Amendment to the Drawings

FIG. 3

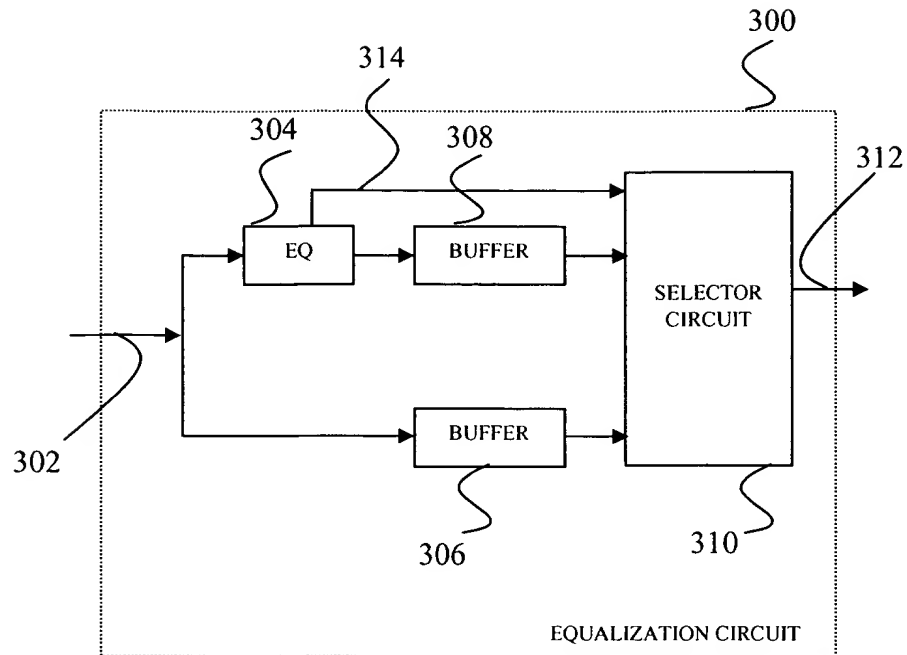
The attached sheet(s) of drawings include changes to Fig(s). 3 & 4. These sheet(s), which include Fig(s).3 & 4, replaces the original sheet(s) including Fig(s). 3 & 4. Figure 3 has been amended to show control signal 314 in equalizer 304 which goes to selector circuit 310. Figure 4 has been amended to show decoder bank 412 within equalizer circuit 400.
